## Toyota Aygo / Citroën C1 / Peugeot 107 Clutch Kit Replacement

**Applicable References:** ADT330246, ADT33351, ADT33352

**Date Issued:** 02/2014

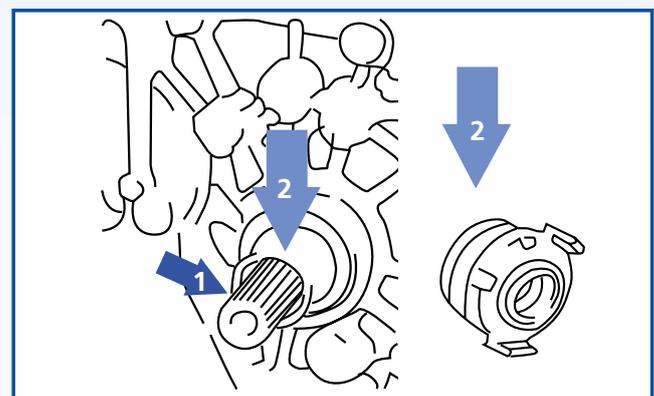
**Please note:** The manufacturer has issued a service bulletin to highlight that the design of the fork has been improved to prevent future issues with heavy clutch operation and release lever damage, therefore, if you find stress fractures on the clutch release lever, replace both the clutch fork and the clutch release lever with Blue Print part numbers **ADT33351** (clutch fork) and **ADT33352** (clutch release lever).

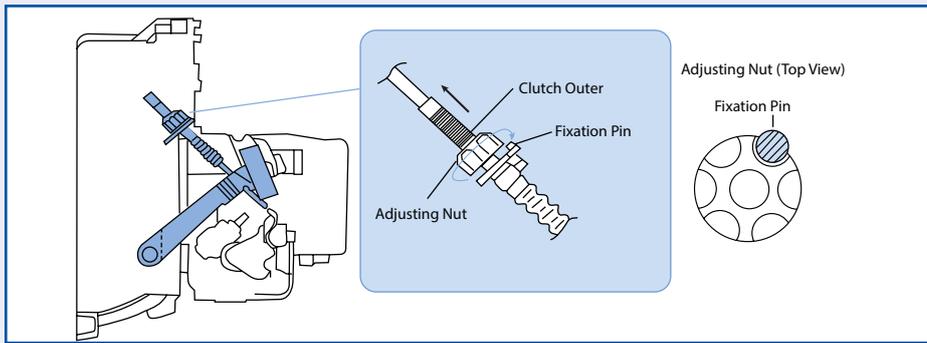
1. Push the clutch pedal down by hand (Fig. 1) checking for smoothness of operation. Stiffness or roughness in operation will require further investigation to determine the root cause.
2. Measuring the free play in the pedal can be done quickly and easily by applying gentle force to the pedal with your hand (approx 15-20Nm) until you feel the amount of pressure required increase. Measure the distance travelled by the pedal with a ruler – the amount of free play in the clutch pedal needs to be 23mm, +/- 5mm (Fig. 2).
